From: Anna Tidey
Sent: 07 January 2025 10:33:45 UTC+00:00
To: "Jonathan Talley" <jon@jtalimited.co.uk>
Subject: RE: DM/24/2933 - 23 Meadow Drive Lindfield Haywards Heath West Sussex RH16 2RS

From: drainage <drainage@midsussex.gov.uk>
Sent: 20 December 2024 17:26
To: Anna Tidey <anna.tidey@midsussex.gov.uk>
Cc: drainage <drainage@midsussex.gov.uk>
Subject: 2024.12.20 Re: DM/24/2933 - App - Minor - 23 Meadow Drive Lindfield Haywards Heath West Sussex RH16 2RS

Thank you for consulting the Flood Risk and Drainage Team with regard to the above application. We understand the application is for demolition of existing garage and erection of a two storey rear and side extension and new front porch. The Flood Risk Assessment provided by the Applicant has been reviewed, and we would comment as follows:

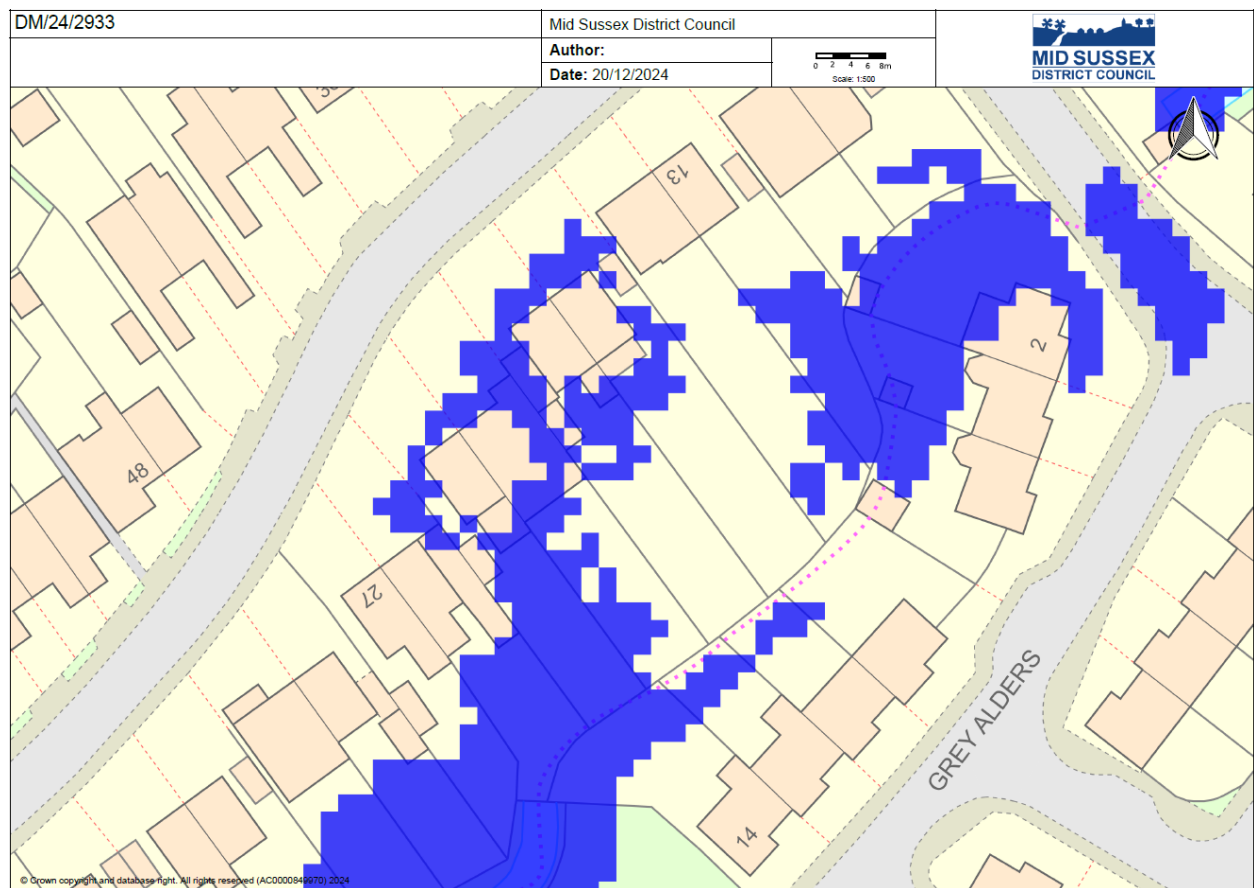
The site is in flood zone 1 and is at low fluvial flood risk (risk of flooding from Main Rivers). The site is shown to be at very low, low, medium, and high surface water flood risk (comparable to flood zone 3b, 3a, 2 and 1).

The proposed development site is located within an area impacted by the 1:30, 1:100 and 1:1,000 flood events (high, medium, and low surface water flood risk). Following the approach set out under the NPPF for assessing fluvial flood risk (flood zones) this area would be considered consistent with Flood Zone 3b (1:30 extent), Flood Zone 3a (1:100 extent), and Flood Zone 2 (1:1000 extent).

Based on the latest guidance that all sources of flooding should be considered consistently the site meets one of the reasons an area would be considered functional floodplain (Flood Zone 3b); it's location within the 1:30 surface water flood extent.

It is the Flood Risk and Drainage Team's findings that, following the latest guidance on assessing flood risk the site is located within the equivalent of Flood Zone 3b

As per the Environment Agency standing advice for minor extensions, development within the 1:30 flood extent is not permissible. In the event that the proposal is outside of this extent then additional resistance and resilience mitigation will need to be evidenced at this location, as this development is classified as 'more vulnerable'

In addition, the Flood and Drainage Team would have no objection to the scheme if surface water modelling can be provided which demonstrates that the development design ensures that, for the 1:100 year + climate change event:

- Site users are safe in the event of a flood
- There is no loss of floodplain storage
- There is no impedance of overland flows
- There is no increase in flood risk
